STAFF REPORT

HEARING DATE: June 1, 2021
TO: Mayor & City Council
FROM: Sonya Allen, Associate Planner
208-884-5533
SUBJECT: H-2021-0014
Artemisia Subdivision – AZ, PP
LOCATION: 1690 W. Overland Rd., in the SE ¼ of
Section 14, T.3N., R.1W. (Parcel
#S1214449107)

Annexation and zoning (AZ) of 25.67-acres of land with a C-G (General Retail and Service Commercial) zoning district; and, Preliminary Plat (PP) consisting of 9 commercial buildable lots on 19.26-acres of land in the proposed C-G (General Retail and Service Commercial) zoning district.

B. Preliminary Plat & Phasing Plan (date: 1/27/2021)

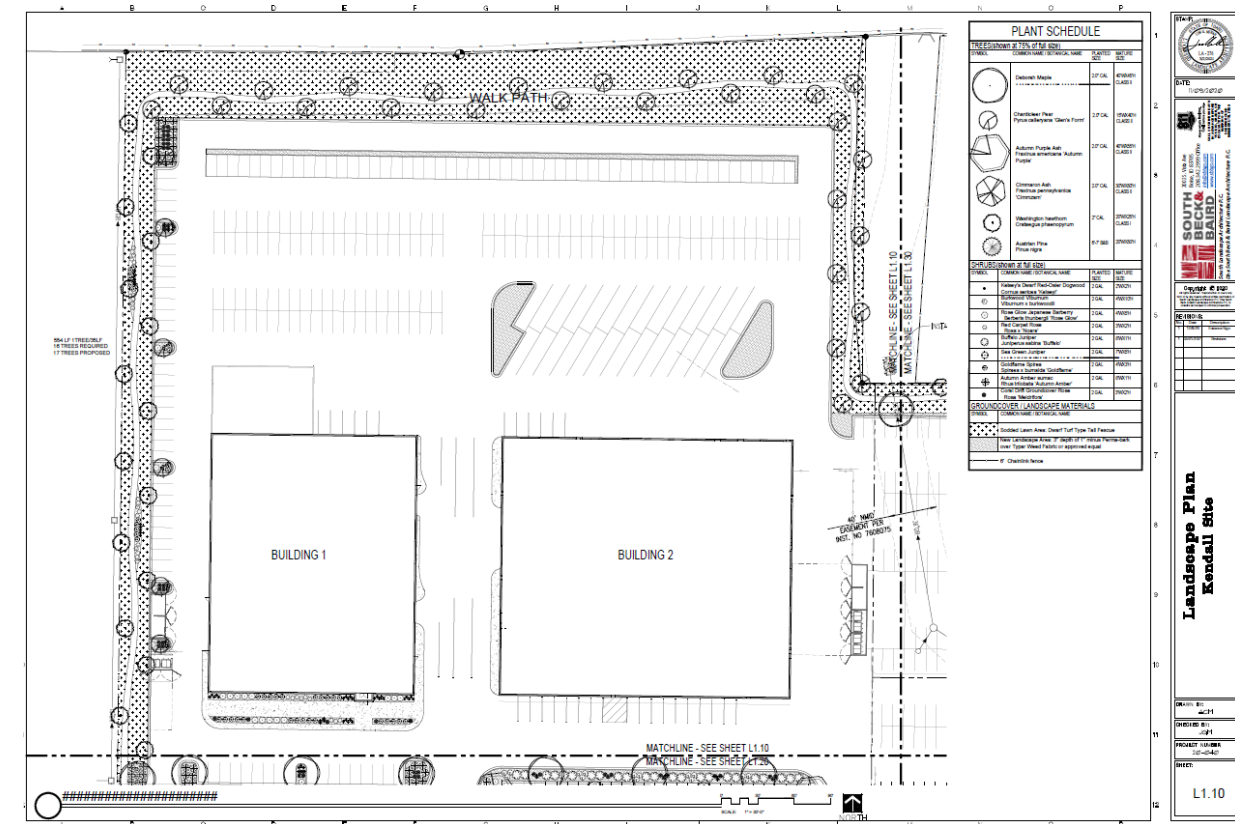
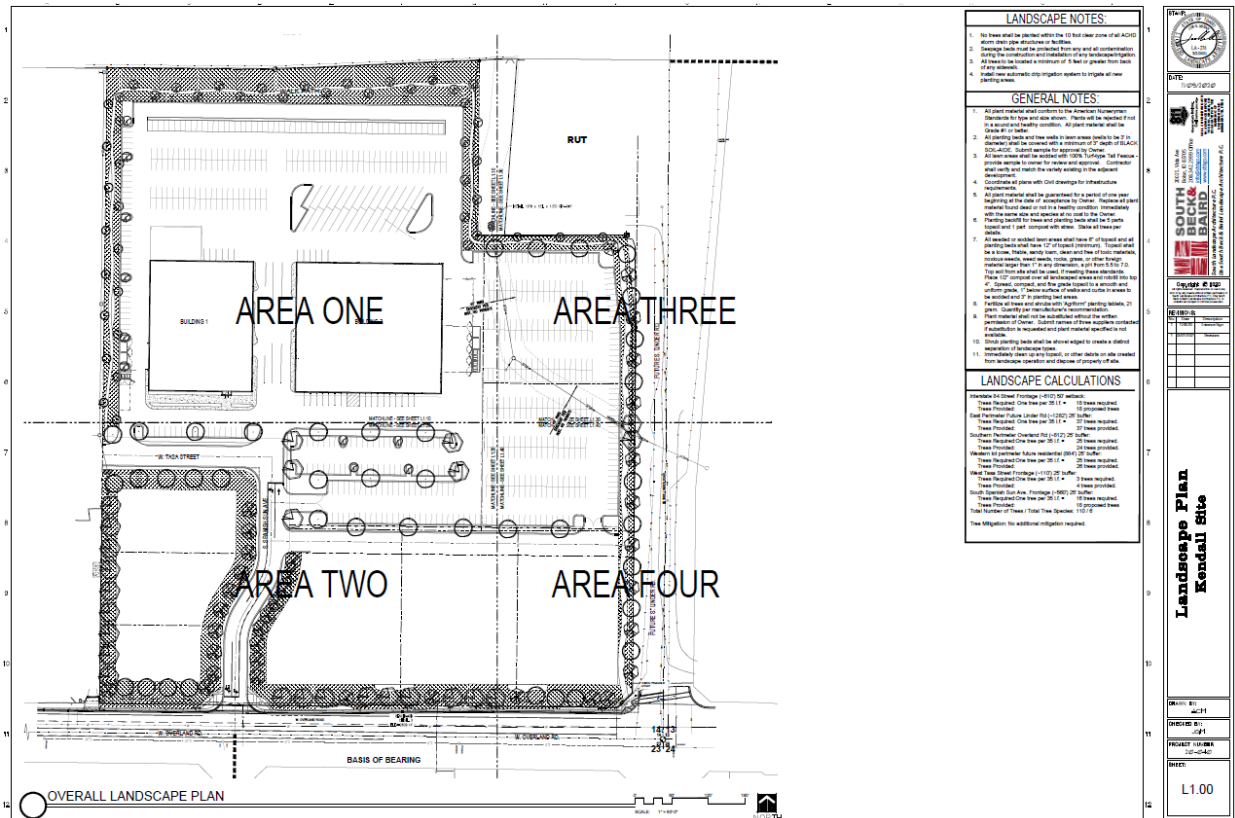
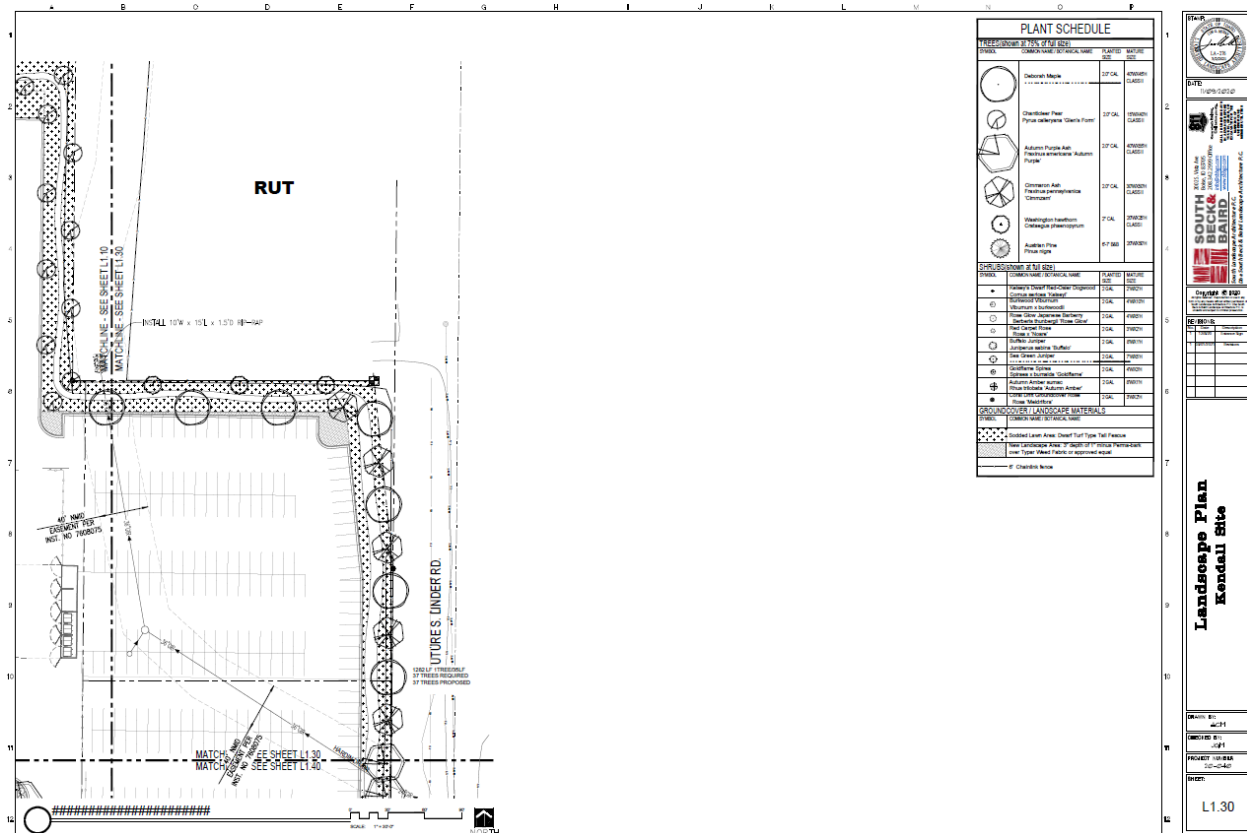
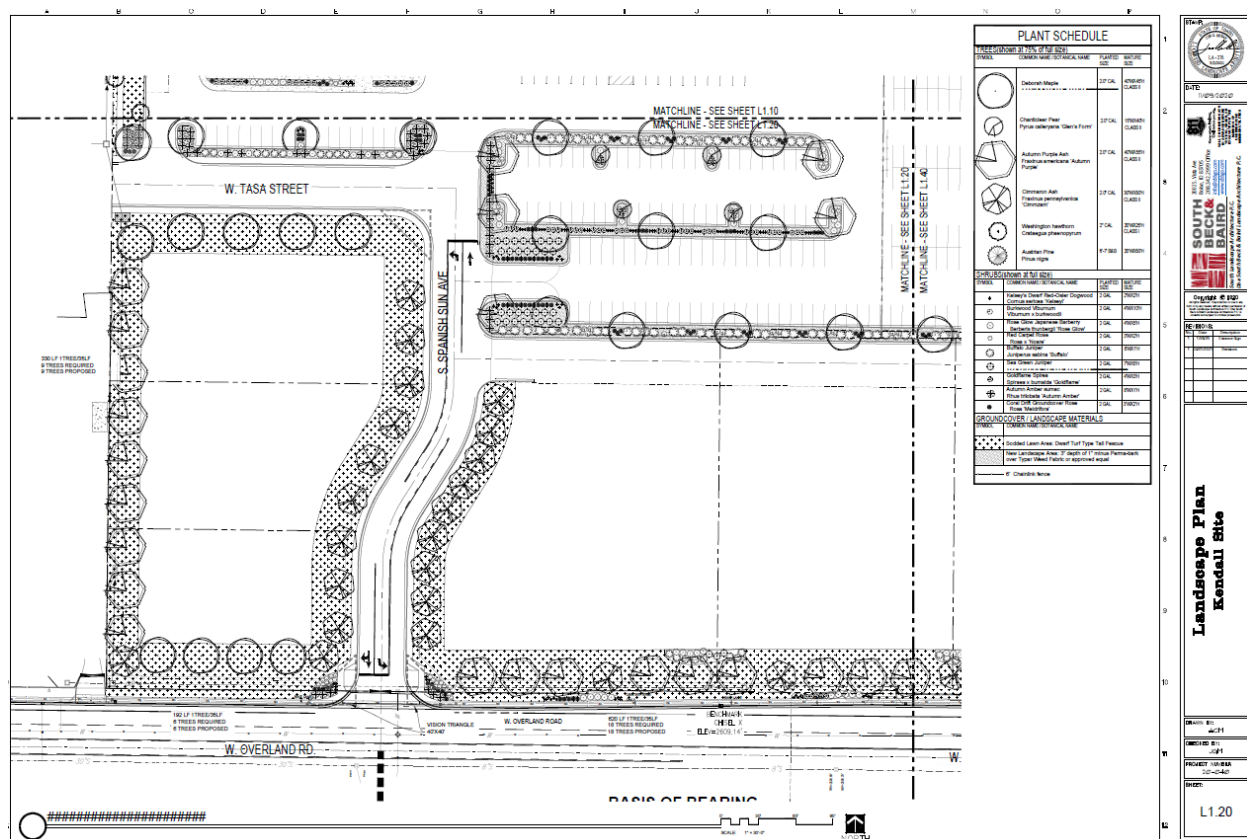
*The landscape plan depicts a pedestrian walkway within the landscape buffers around the perimeter of the development and sidewalks along internal public streets. **Additional internal pedestrian walkways should be provided between buildings within the site for pedestrian connectivity and from the perimeter sidewalks along Overland and Linder Roads to the main building entrances.***

One (1) stub street (W. Tasa St.) is proposed to the west boundary for future extension in accord with the Transportation System Map in the TMISAP. A temporary cul-de-sac is required to be constructed at the terminus of Tasa St. until the street is extended in the future.

A 10' wide detached multi-use pathway is proposed as required within the street buffer along S. Linder Rd. in accord with the Pathways Master Plan. **The pathway should be placed in a 14-foot wide public use easement, which shall be submitted to the Planning Division prior to submittal for City Engineer signature on the final plat(s).** If the pathway will be located entirely within the right-of-way, a public pedestrian easement is not needed.

The preliminary plat depicts an existing ITD storm drainage facility at the northeast corner of the site that is proposed to remain.

All fencing is required to comply with the standards listed in UDC 11-3A-7. A 6-foot tall chain-link fence exists around the ITD storm drainage facility which is proposed to remain. **No fencing is depicted on the plan around the Kendall Ford; Staff recommends if fencing is proposed for security that it be of a higher quality than chain-link (i.e. wrought iron) – the Applicant should clarify at the hearing if fencing will be proposed and if so, what type of fencing is proposed.**

- c. Minimum 5-foot wide pedestrian walkways shall be provided from the perimeter sidewalks along Overland and Linder Roads to the main building entrances in accord with UDC 11-3A-19B.4a.

- d. Internal pedestrian walkways shall be provided between buildings within the site for pedestrian connectivity. Internal walkways shall be distinguished from the vehicular driving surfaces through the use of pavers, colored or scored concrete, or bricks in accord with UDC 11-3A-19B.4b.

- 2. The final plat shall include the following revisions:
 - a. Include a note prohibiting direct lot access via W. Overland Rd. and S. Linder Rd.
 - b. Include a note granting cross-access/ingress-egress easements between all lots in the subdivision in accord with UDC [11-3A-3A.2](#).

- 6. A 14-foot wide public use easement for the multi-use pathway along S. Linder Rd. shall be submitted to the Planning Division prior to submittal for City Engineer signature on the final plat(s). *If the pathway will be located entirely within the right-of-way, a public pedestrian easement is not needed.*
